Meadow View,

Well Lane, Gillow Heath
Extension & Alterations

Proposed Elevations Sheet 1

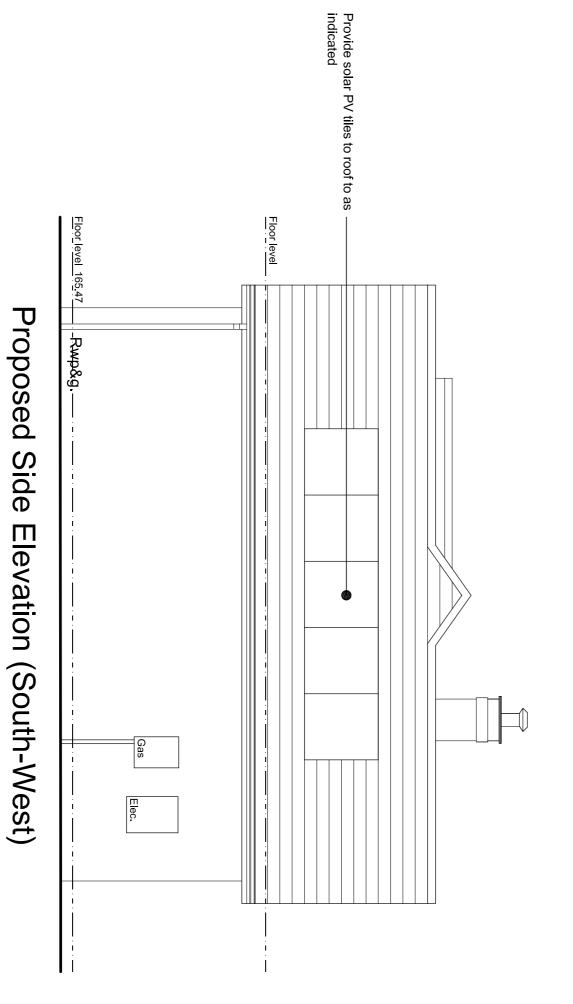
Rev. F. Solar PV tiles added to South-West roof slope.

Rev. E. Design revised to provide garage below garden with revised slab level to provide reduced engineering works.

Rev. D. Design revised in accordance with clients comments to provide garage below main dwelling.

Rev. C. Sub-terranean garage removed, design revised and garage provided attached to main dwelling.

Rev. B. Garage slab level revised to reduce excavation and engineering works further to the local authority's comments.

Rev. A. Drawing information revised to enable validation in accordance with SMDC's new requirements.
